# Rezoning Transportation Analysis

Petition Number: 2021-174

Date	Description
11-22-21	First Review (TM)
12-17-21	Second Review (WB)

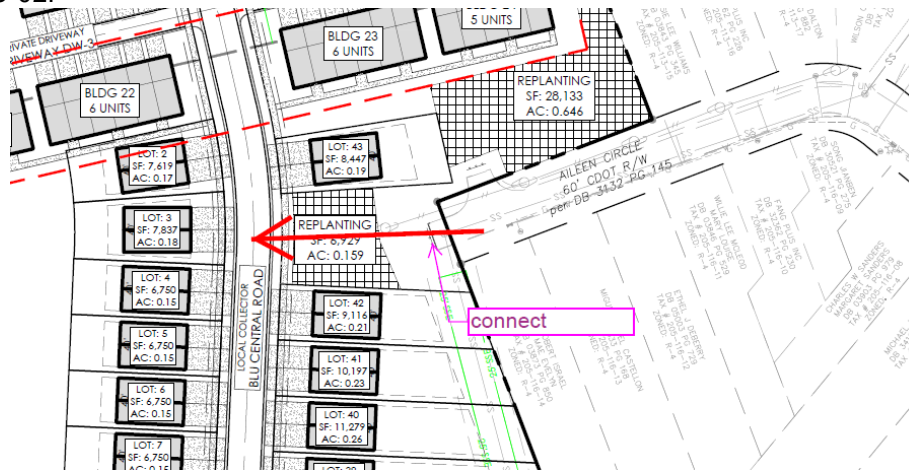
1. **Curblines:** The proposed zoning district has a setback measured from back of the future curblines.
  - a. **East Westinghouse Boulevard:** The future back of curb and gutter shall be installed at 33 feet from the existing street centerline. Revise site plan to show the future back of curb.

Label and dimension the existing and future curb and gutter from the centerline for each road on the site plan.
